SAFETY RECALL NOTICE

Re: iCatch™ System May Not Properly Secured the Personal Watercraft

Campaign no.: 2010-0005

Subject: **iCatch™ System May Not Properly Secure the Personal Watercraft**

Settings Tables

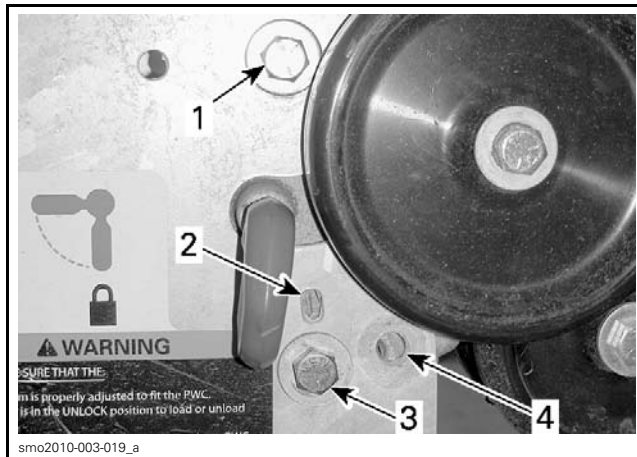
SETTING TABLE "A"		
iCatch housing angle setting		2
iCatch support height setting (lower bolt position)		1
Bumper position setting	Bumper holes	2
	Support holes	3
SETTING TABLE "B"		
iCatch housing angle setting		2
iCatch support height setting (lower bolt position)		3
Bumper position setting	Bumper holes	1
	Support holes	1
SETTING TABLE "C"		
iCatch housing angle setting		3
iCatch support height setting (lower bolt position)		3
Bumper position setting	Bumper holes	1
	Support holes	1
SETTING TABLE "D"		
iCatch housing angle setting		1
iCatch support height setting (lower bolt position)		3
Bumper position setting	Bumper holes	1
	Support holes	1

iCatch Housing Angle Setting Procedure

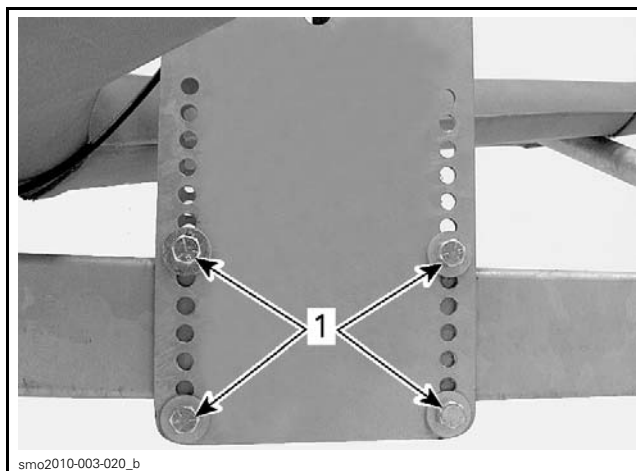
1. Loosen the iCatch housing upper bolt.
2. Remove the iCatch housing lower bolt.

- 3.1 Bring angle to the appropriate setting. The setting refers to the number visible in the window.
- 3.2 Lock iCatch housing in place by inserting the bolt through the appropriate lower hole.

- 3.3 Tighten nuts to $27 \text{ N}\cdot\text{m} \pm 3 \text{ N}\cdot\text{m}$ ($20 \text{ lbf}\cdot\text{ft} \pm 2 \text{ lbf}\cdot\text{ft}$).

iCatch Support Height Setting Procedure

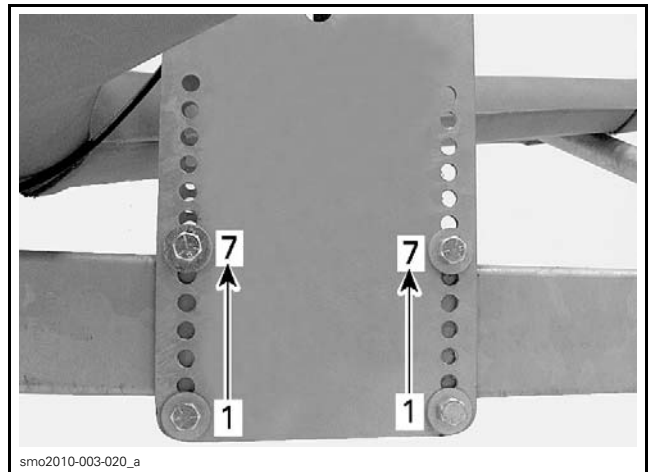
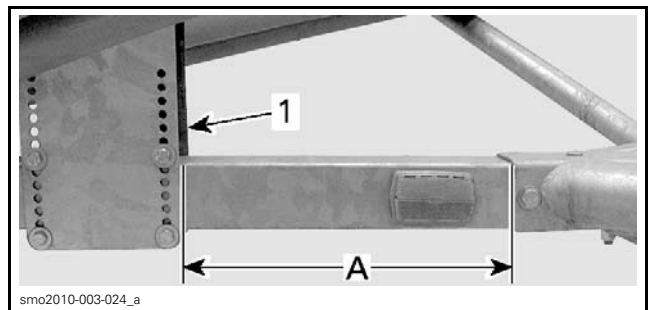
1. Remove iCatch support bolts and install in the appropriate holes.

NOTE: The iCatch support height setting refers to the lower bolt position. Insert upper bolt just above the tongue.

WARNING
There must be precisely 5 unused holes between upper and lower bolts.

2. Progressively tighten nuts in a crisscross pattern until support is square with the trailer tongue. Do not tighten yet.
3. Adjust tongue weight, refer to *TONGUE WEIGHT ADJUSTMENT* below.
4. Final tightening is $8 \text{ N}\cdot\text{m} \pm 1 \text{ N}\cdot\text{m}$ ($71 \text{ lbf}\cdot\text{in} \pm 9 \text{ lbf}\cdot\text{in}$).

Bumper Position Setting Procedure

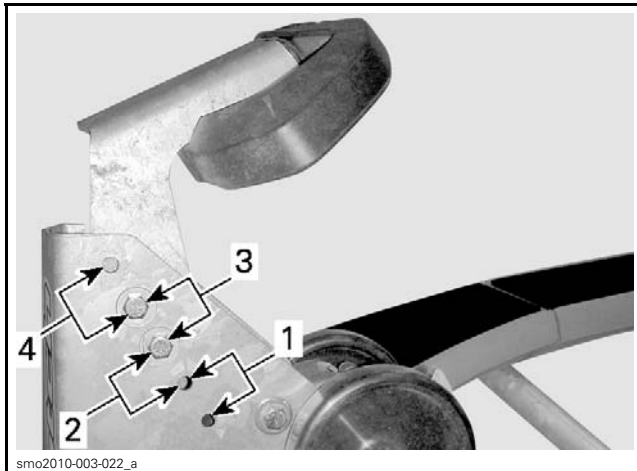
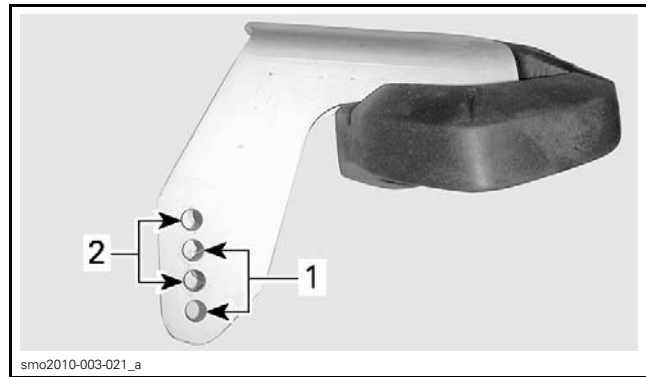
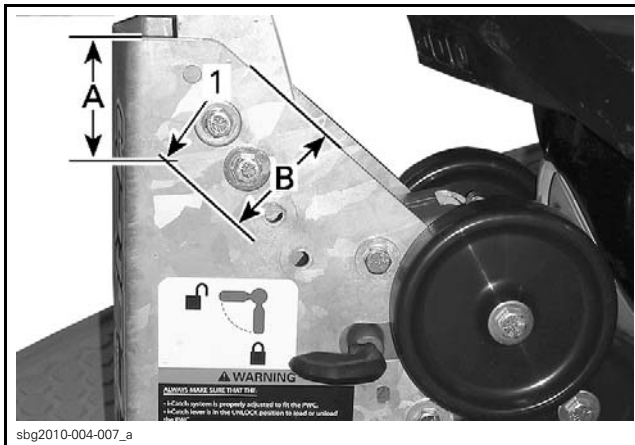
1. Remove bumper retaining bolts.
2. Align appropriate support holes and bumper together.

3. Install bolts loosely into proper positions.
4. **IMPORTANT:** Move bumper upwards then towards front and maintain it in this position.

5. Tighten bolts to $36\text{ N}\cdot\text{m} \pm 3\text{ N}\cdot\text{m}$ ($27\text{ lbf}\cdot\text{ft} \pm 2\text{ lbf}\cdot\text{ft}$).

NOTE: It is important to maintain bumper fully upwards and forward to eliminate any play in the assembly before tightening.

Fixed Cable End Installation

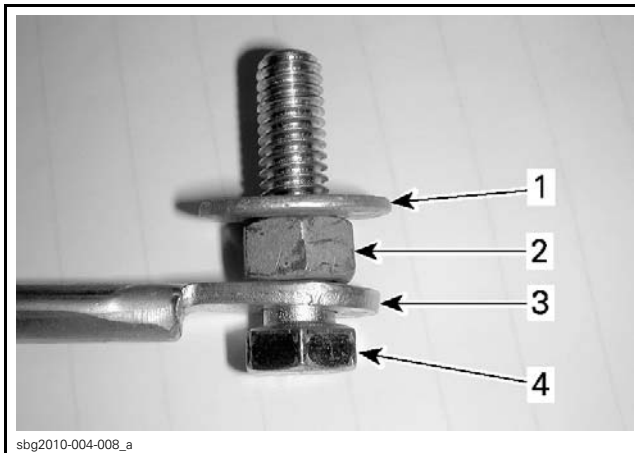
1. Draw a mark on the iCatch support at the location shown.

1. Draw a mark here
- A. 65 mm (2.56 in)
- B. 68 mm (2.68 in)

2. Punch the mark.
 3. Drill a pilot hole.
 4. Drill a 10 mm (3/8 in) hole.
 5. Pass the 3/8 bolt through the cable eyelet.
 6. Thread the 3/8 nut on the bolt until it stops.
- NOTE:** Make sure the cable eyelet turns freely.
7. Pass a washer on the bolt.

Safety Cable Fastening Pin Installation

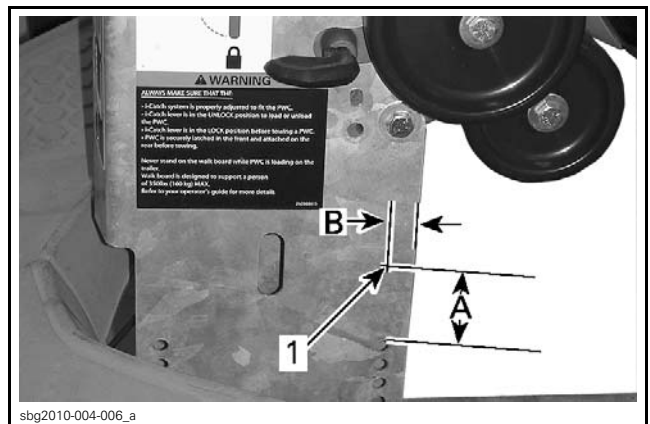
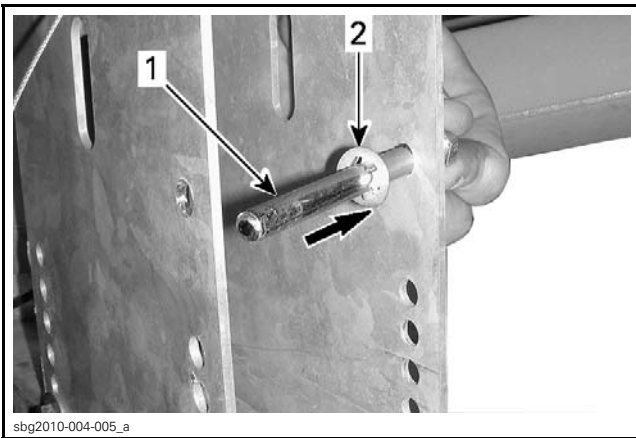
1. Draw a mark on the LH side of iCatch support at the location shown.

1. Draw a mark here
- A. 60 mm (2.36 in)
- B. 16.5 mm (.65 in)

2. Draw a mark on the RH side of iCatch support using the same measures. The holes must precisely face each other.
3. On each side:
 - Punch the mark.
 - Drill a pilot hole
 - Drill a 8 mm (5/16 in) hole

4. Pass the pin through the RH hole, then pass a push nut on the pin.

Hairpin Clip Installation

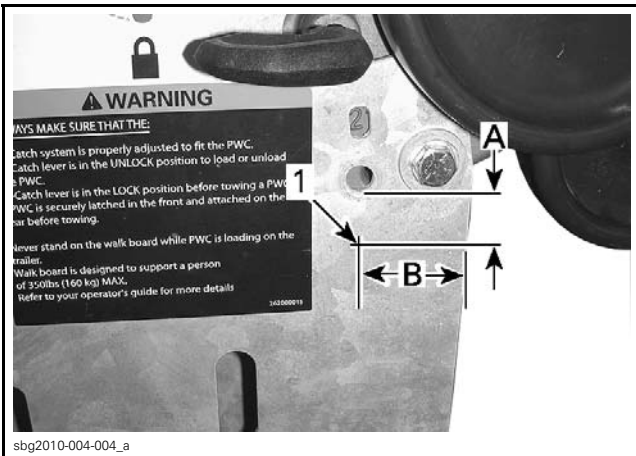
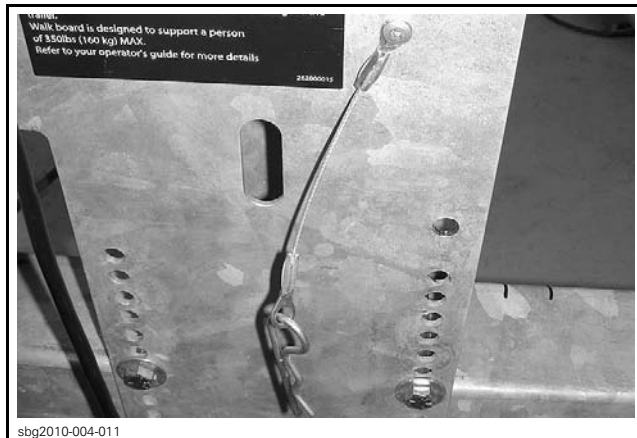
1. Draw a mark on the iCatch support at the location shown.

1. Draw a mark here
- A. 25 mm (.98 in)
- B. 43 mm (1.69 in)

2. Punch the mark.
3. Drill a 5 mm (13/64 in) hole.
4. Install one eyelet of the small cable on the iCatch support using the 4.8 mm (3/16 in) rivet.
5. Pass the hairpin clip on the other eyelet.

Securing the Watercraft Using the Safety Cable

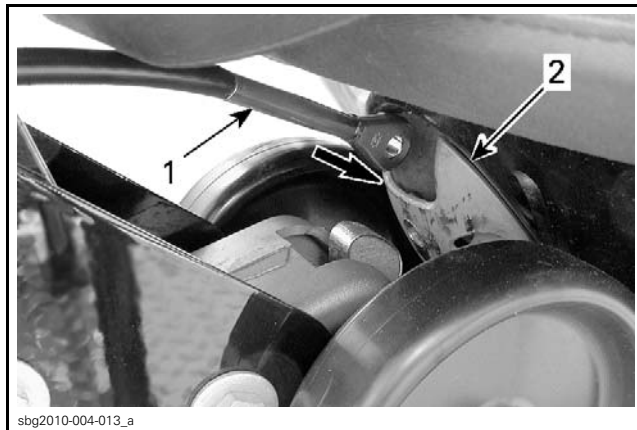
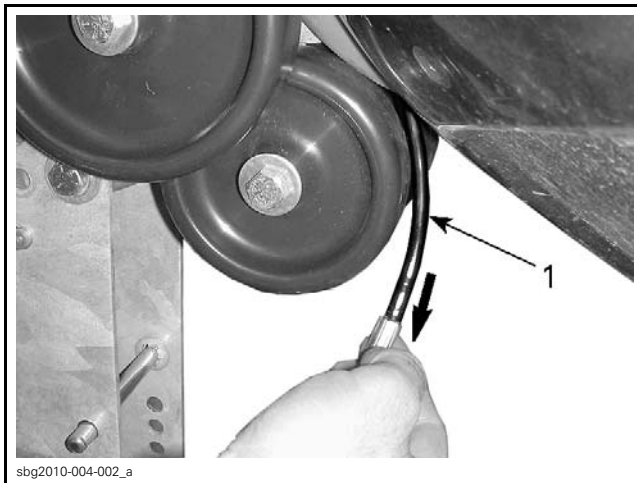
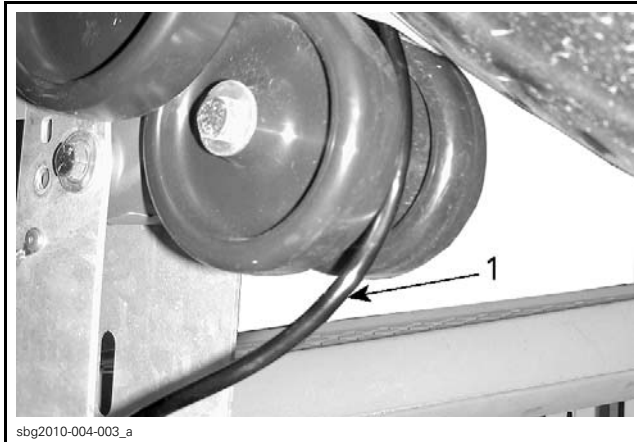
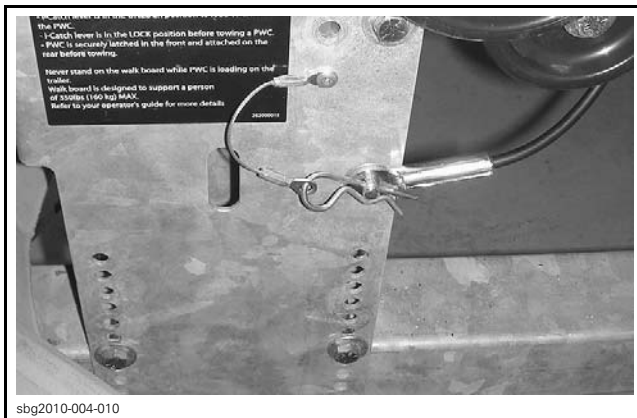
1. Make sure the PWC is correctly latched to the iCatch mechanism.
2. Pass the cable through the bow cup.

Inspect safety cable before every use. Replace a damaged cable before trailering.

NOTE: Make sure that the safety cable passes between the lower iCatch mechanism wheels.

3. Attach the cable to the fastening pin.
4. Secure safety cable to the fastening pin using the hairpin clip.
